PROJECT: Wallowa Memorial Hospital MOB  
TO: Clark/Kjos Architects\*

DATE: 11/03/2011  
RE: 101-211300-Fire Sprinkler System Shop Drawing  
Resubmittal

Re: Wallowa Memorial Hospital MOB.  
Enterprise Or.

**Riser Detail**  
Scale: N.T.S.  
Note: Underground to be flushed and hydrostatically tested per NFPA 13 and local codes prior to connecting sprinkler system

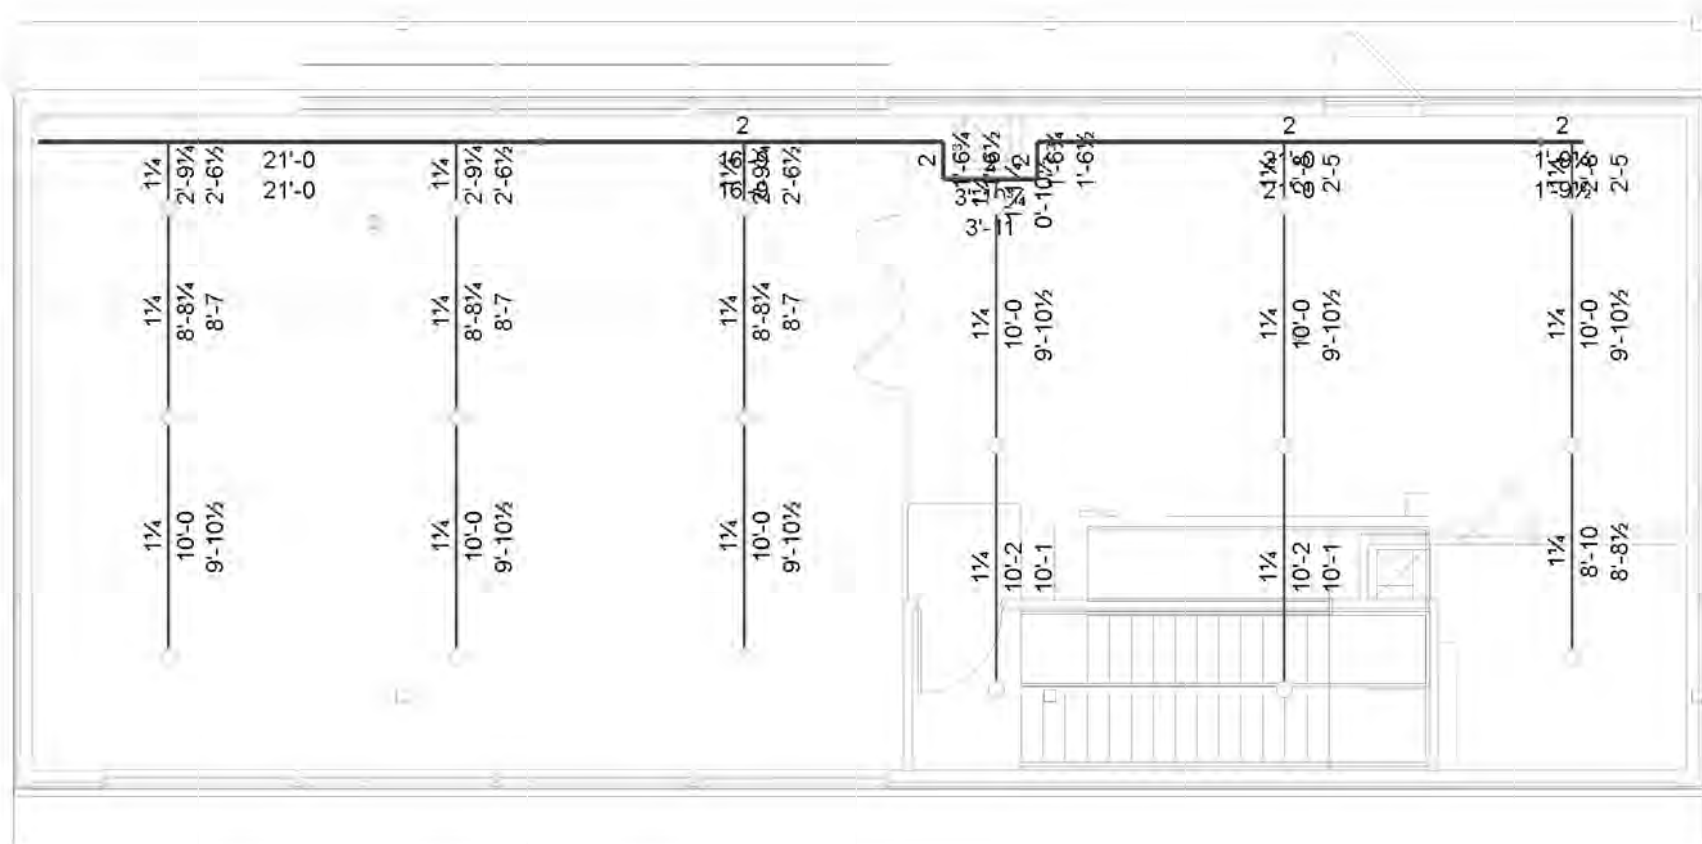
- 1) *Drawings Submitted are not signed and sealed by Professional Engineer.*  
**Drawing/Calcs have been reviewed and signed. ✓**
- 2) Provide method for forward flow testing backflow.

- 9) No bell is shown. Please provide.  
**Notes for bell have been added to riser. ✓**
- 10) Sheet FP-1 does not show dry pipe valve trim, including gauges. Please provide full trim.

**Detail has been added to riser. ✓**
- 13) Fire department connection is not shown to have a ball drip valve for drainage. Please provide, with drain to sewer or daylight.

**Testing of backflow is provided through a 2.5" drain line. See riser diagram. ✓**
- 3) Sheet FP-2 & FP-3: No sprinkler protection has been provided at combustible construction Exits at gridline 1 between gridlines C&D and between gridlines D&E. Please provide.

**Detail has been added to riser. ✓**
- 11) No air compressor is shown  
**Detail and material cut sheets have been added to package. ✓**
- 12) No spare sprinkler box is shown. Please provide.

**Ball drip is show on check valve. ✓**
- 14) Length of ½" thru bolt fastening longitudinal and lateral sway bracing is not provided. Please provide. Identify structural members on drawings showing that the member to which the fastener will be attached is thick enough to hold the entire required length of the thru bolt identified in sway brace calculations.

Date	9/20/11
Scale	1/8"=1'-0"
Job No.	11-137FS
Drawn By	F.CALLFAS
Sheet No.	FP-4

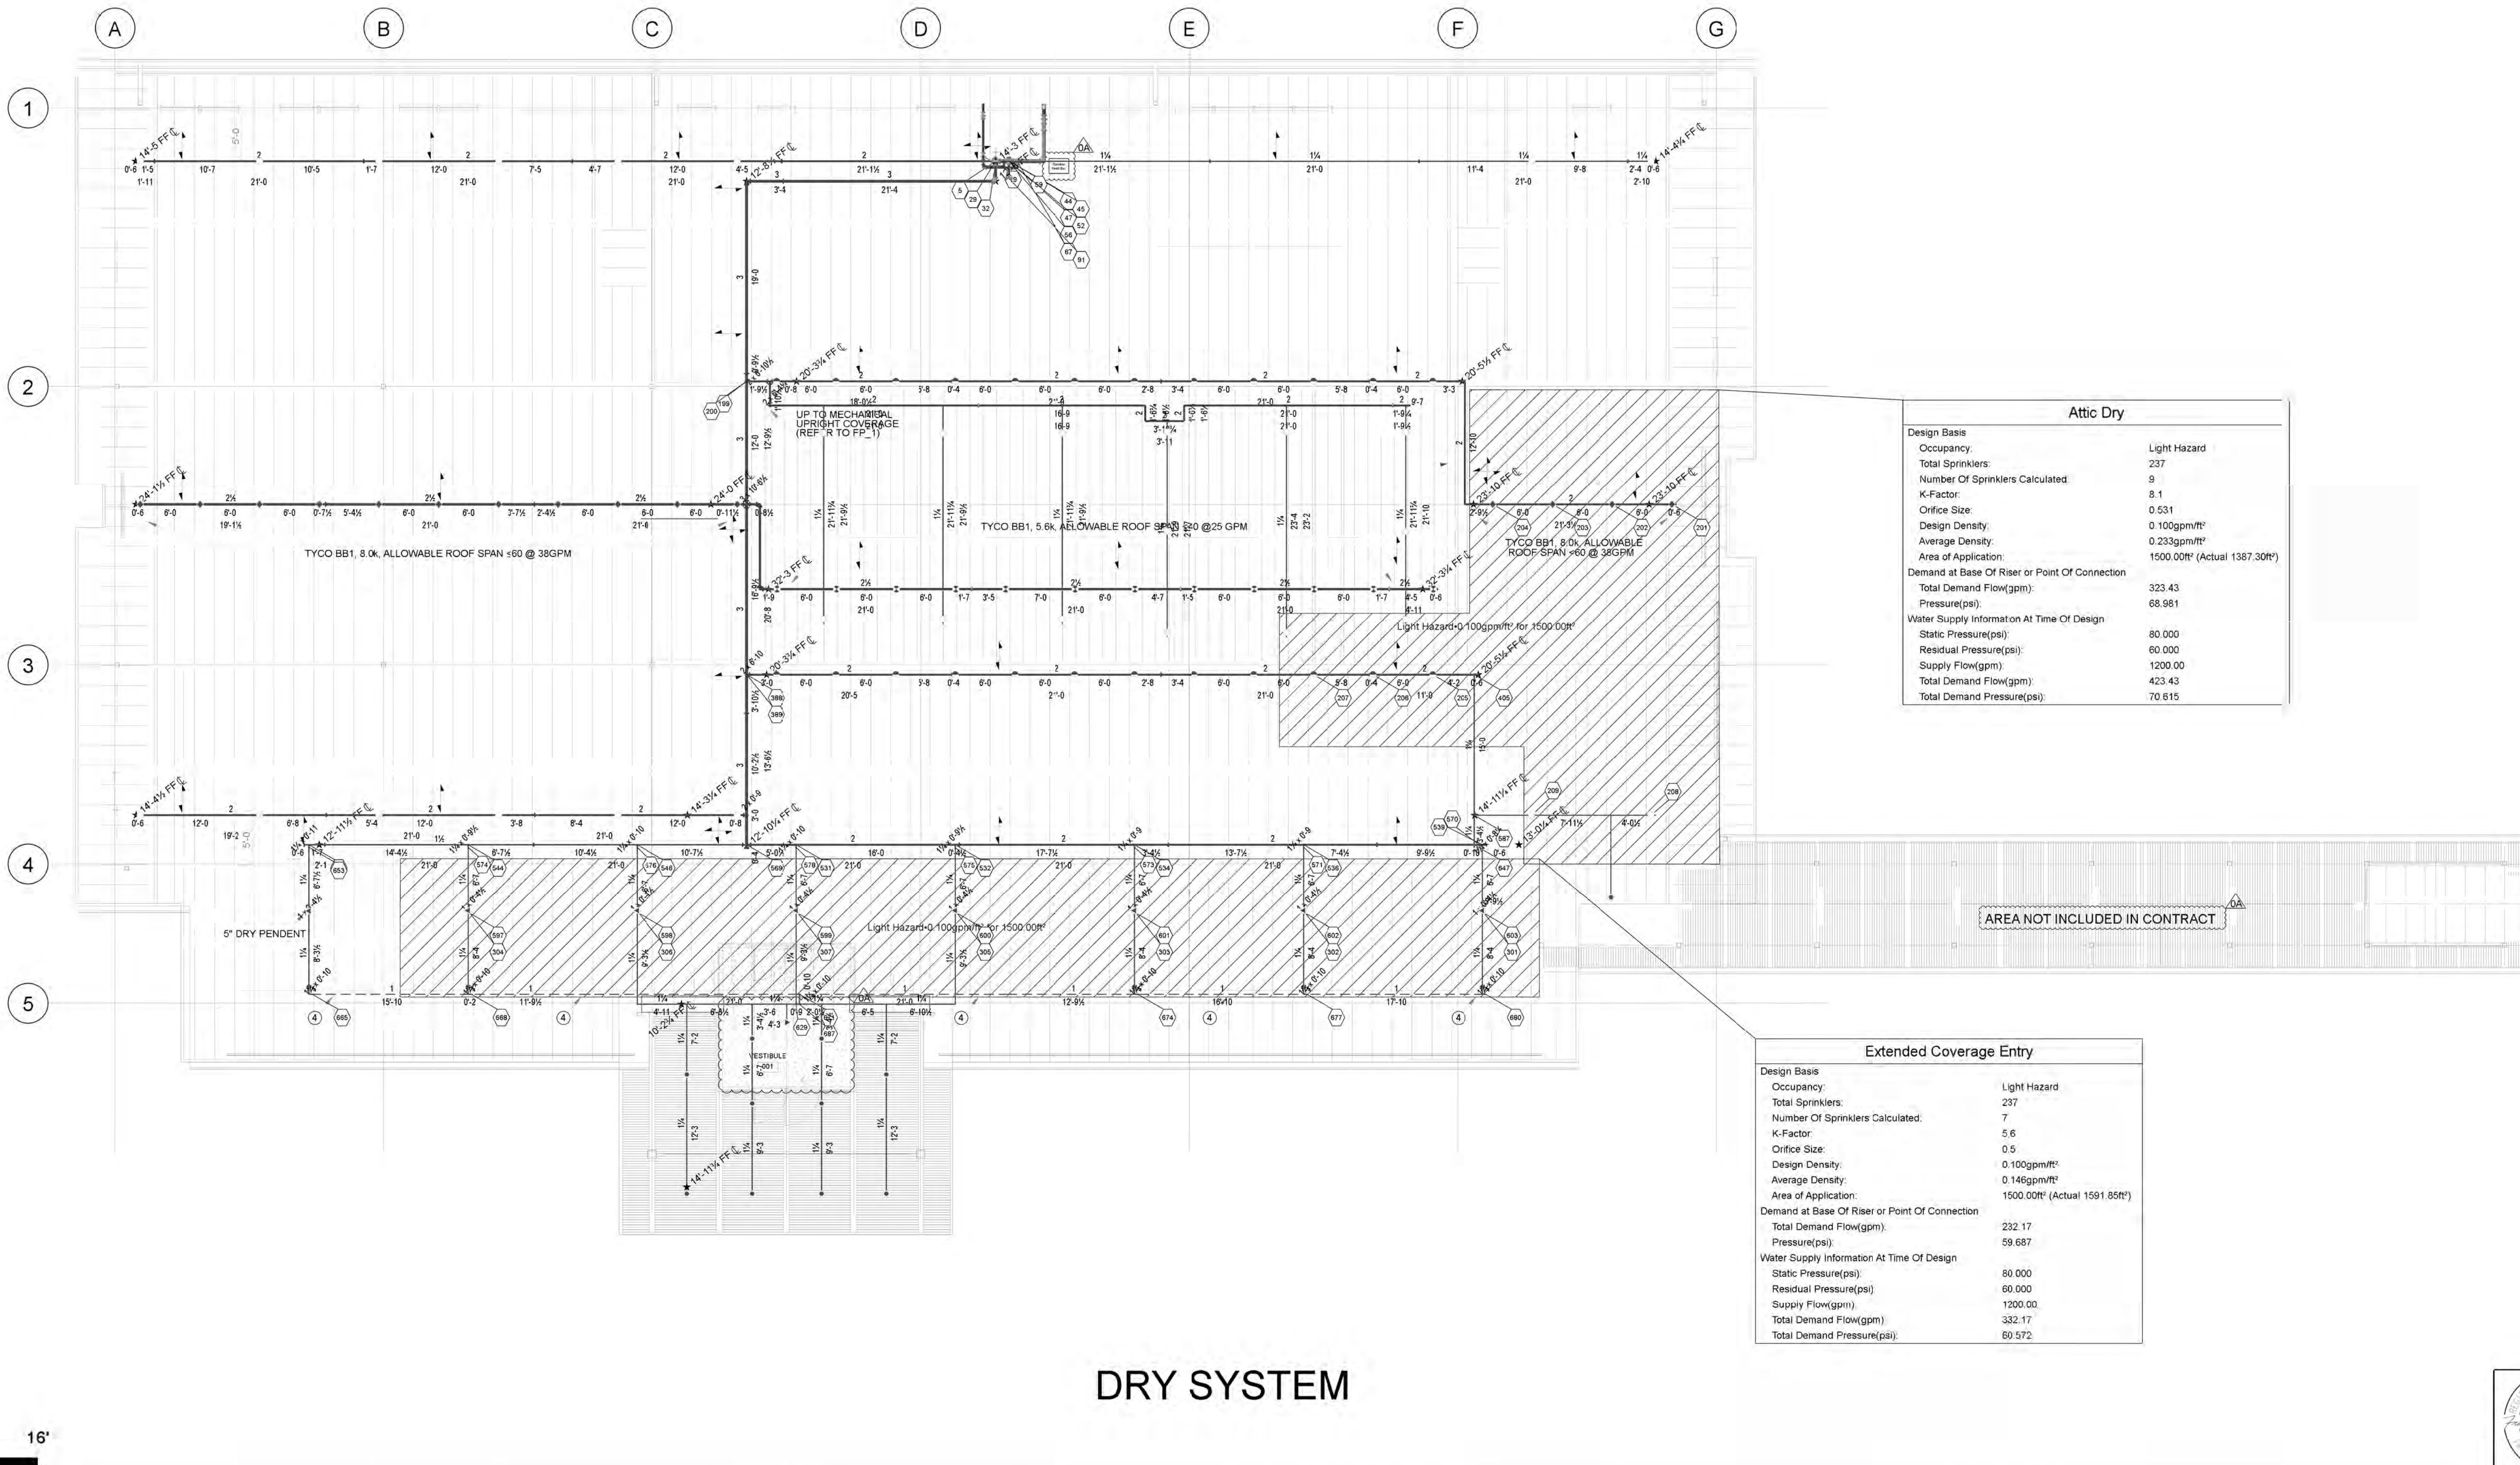
**Dry Pendants Sprinklers have been added in three locations. ✓**
- 4) Sheet FP-4: Dry system routing at Lobby 002 and Vestibule 001 does not coincide with dry system routing shown on sheet P2.11. Verify acceptability of routing with architect.

**SWG 10 will be utilized. See Hanger #8. ✓**
- 16) Sheet FP-4, the last standard coverage sprinkler at the right-hand end of the canopy is more than 7'6" from the end of the canopy. This area does not meet the criteria of being a "small room" as described in NFPA 13-2007 3.3.15 and so no standard coverage sprinkler may exceed half the allowable distance between sprinklers. Please revise.

**Routing of fire main has been modified for coordination and installation over corridor. Spec section 21.1.04.c only calls out coordination with the architect for area containing exposed piping. ✓**

**The walkway is deleted from the fire sprinkler project scope. ✓**
